Access Compliance Report

Public Rights-of-Way

(Pedestrian Signals)

Intersection ID: N/A	Main Street:	Cross Street: N/A	Location: N/A
ADA ID: 26037C120703	Signal Type: Two Push Buttons-Non APS	Overall Compliance: No	Severity Score: BTN 1:N/A BTN 2: N/A No BTN: N/A
Codes/Mitigation Info/Possible Solution		Field Measurements/Component Compliance

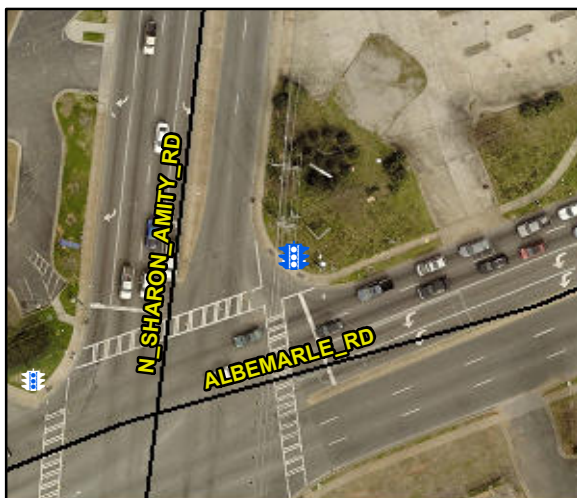
Possible Solutions: Replace Signal Push Button With APS Button on New Post. Remove & Replace Sign.

Surveyor Notes: B1 TEXT HT 7/16, B2 TEXT HT 5/16

PROW/ADA: R410.6, R209.1, TMUTCD 4e.08, R404.2, R406.2, R404.3,
